Kansas Department of Agriculture  
 Division of Water Resources  
**CHANGE: P/D WORKSHEET**

**Water Right, File No. 18,953**  
Change in Point of Diversion Application Map  
5-28S-19W // Kiowa County

**Water Right, File No. 18,953**  
 Change in Point of Diversion, Aerial Map  
 5-28S-19W // Kiowa County

RE: Water Right File No. 18953  
Change in the Point of Diversion

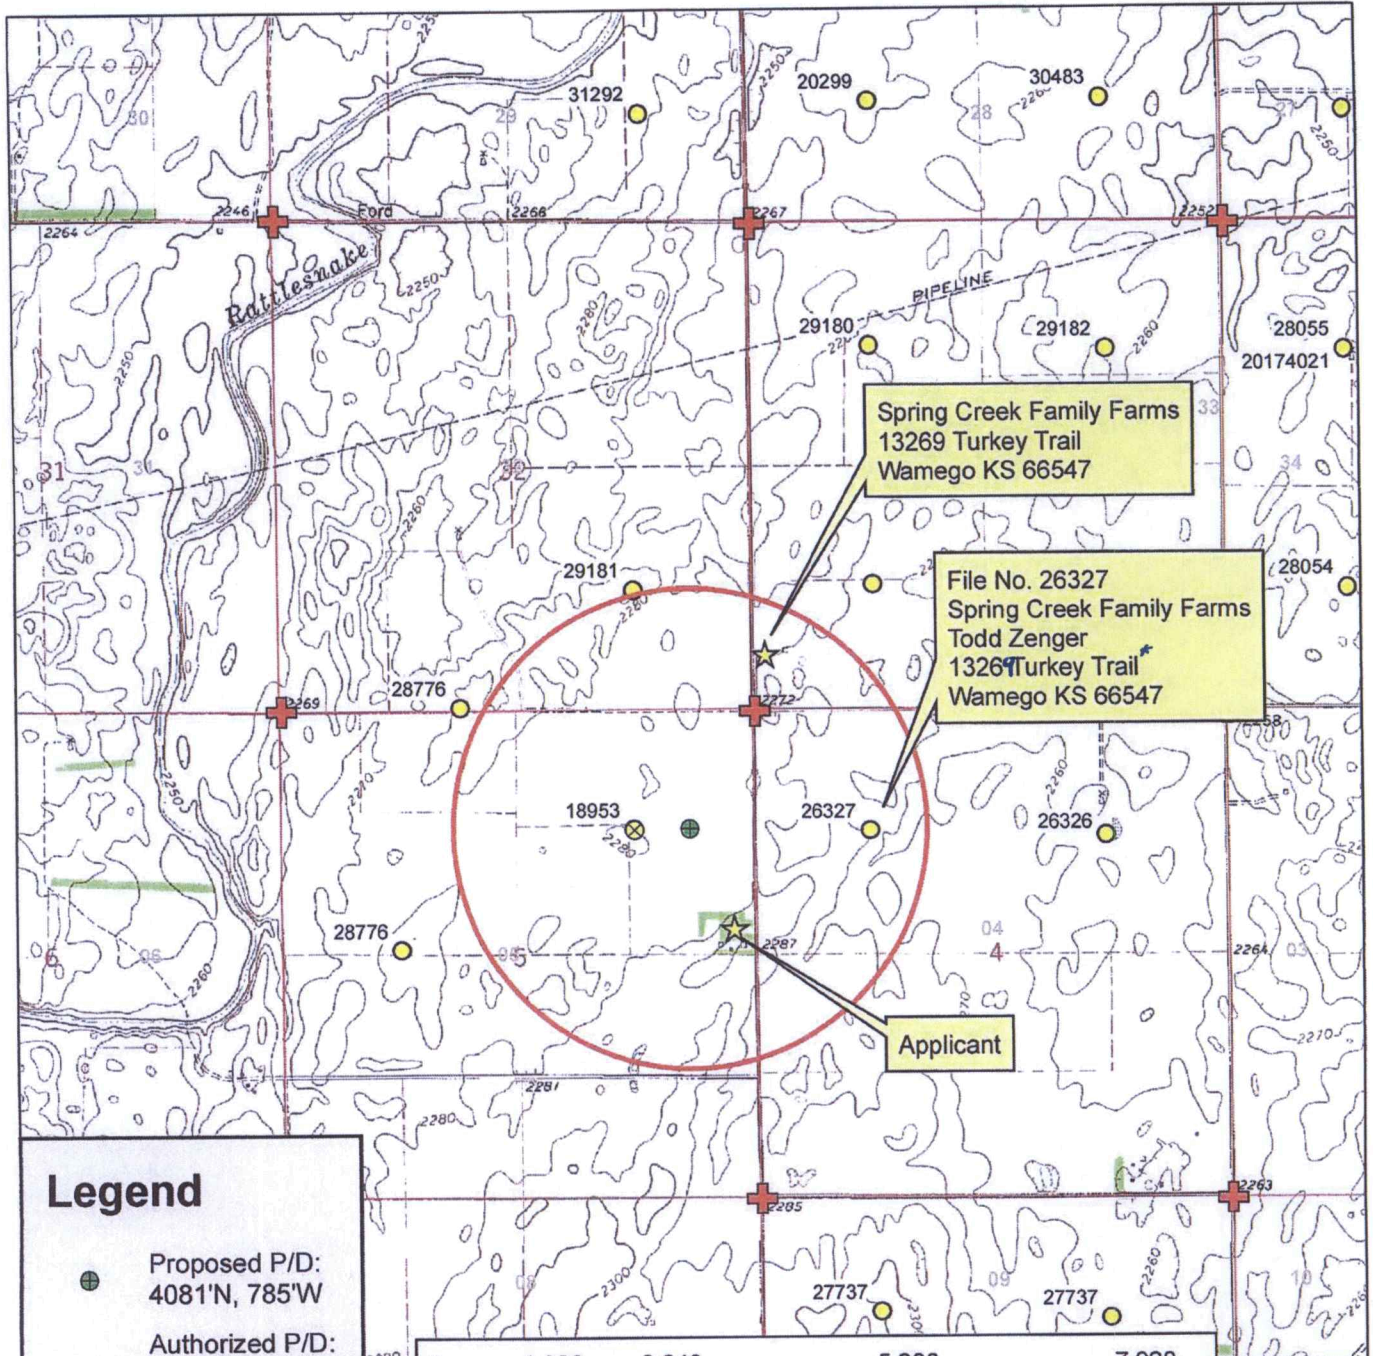
Big Bend Groundwater Management District #5 has reviewed the above referenced application to change the point of diversion. It is the understanding of the District that this change is intended to re-drill a well that has gone bad. Based upon information received in the District office, the application appears to be consistent with 5-25-20(b) and is therefore recommended for approval.

The application to change is subject to the District's well equipment regulation K.A.R. 5-25-5 for a required flow meter.

- 3. The change in point of diversion shall not impair existing rights and shall be limited to the same source or sources of water as previously authorized. The point of diversion authorized by this summary order shall be located within a 300 foot radius of the authorized point(s) of diversion.  Applicable  Not Applicable

- 4. The point(s) of diversion authorized herein shall not actually be located more than 916 feet from the previously authorized point(s) of diversion.  Applicable  Not Applicable

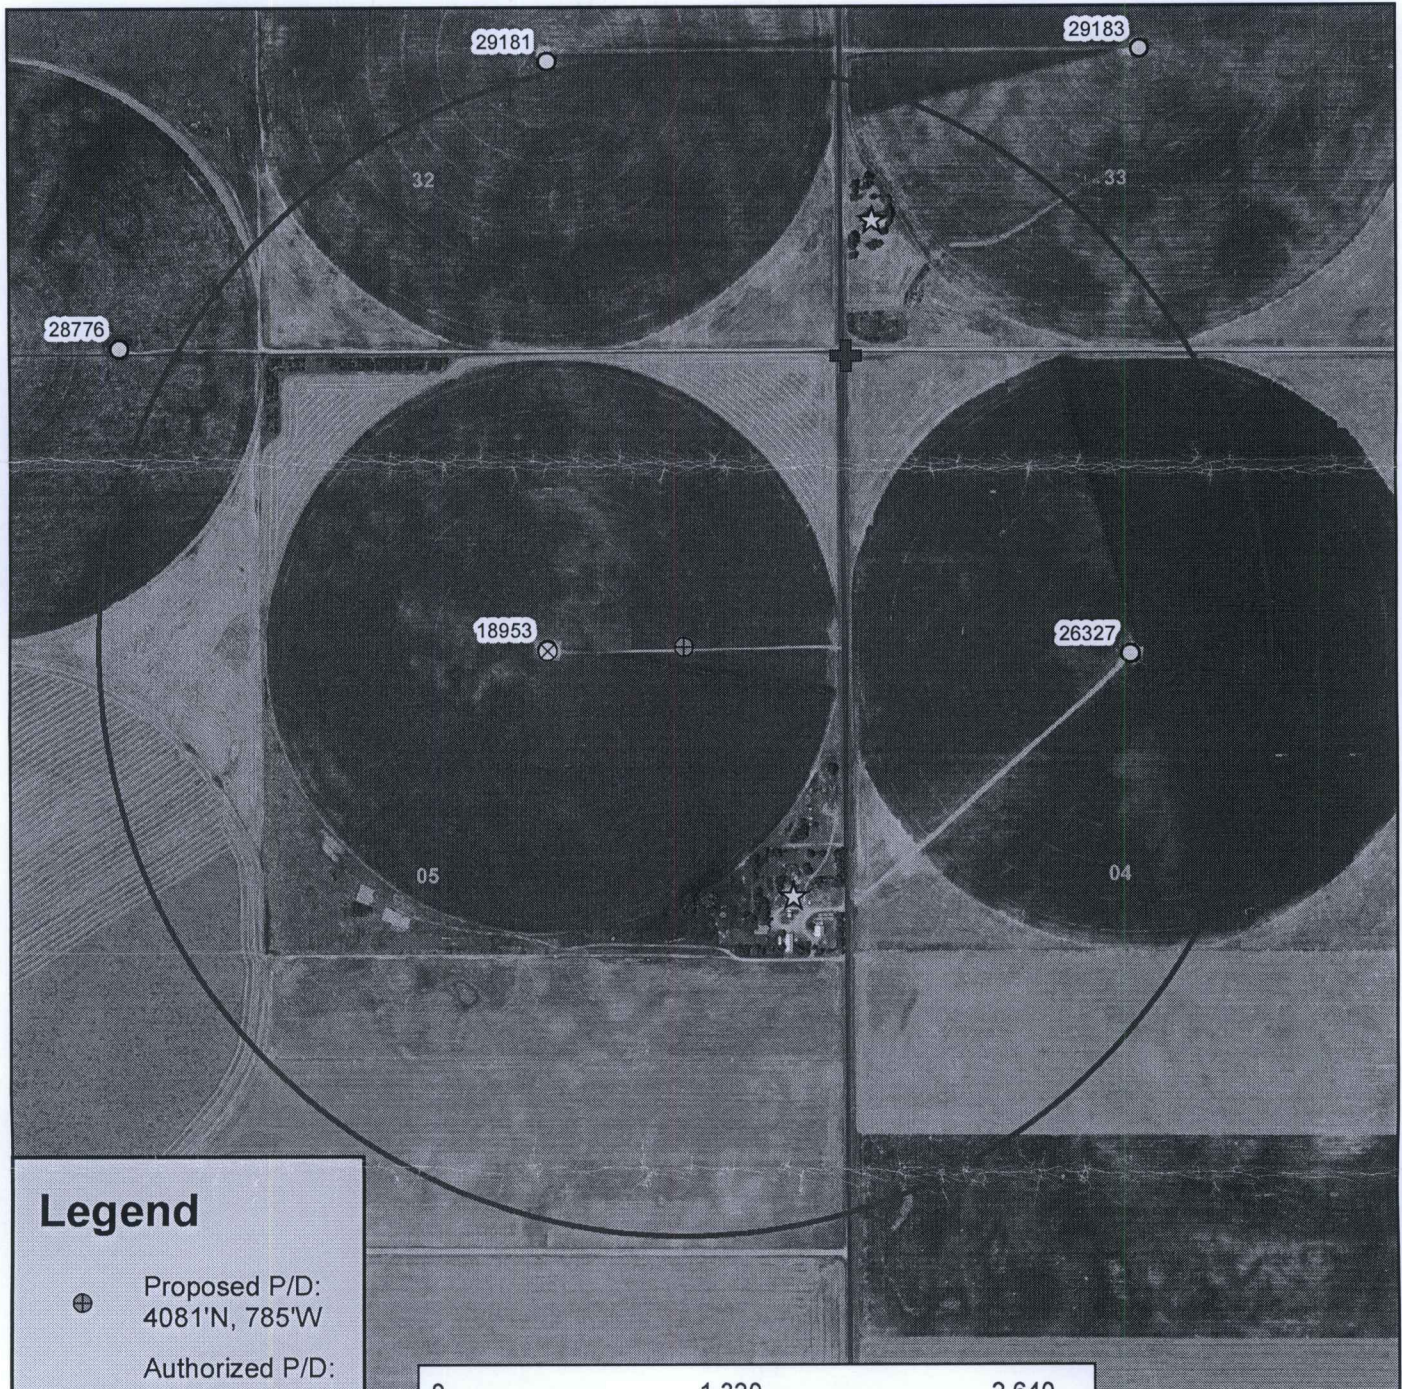
To the best of my knowledge, all water wells including domestic, Field Office  
within 1/2 mile of the proposed point of diversion have been shown. District Water Resources
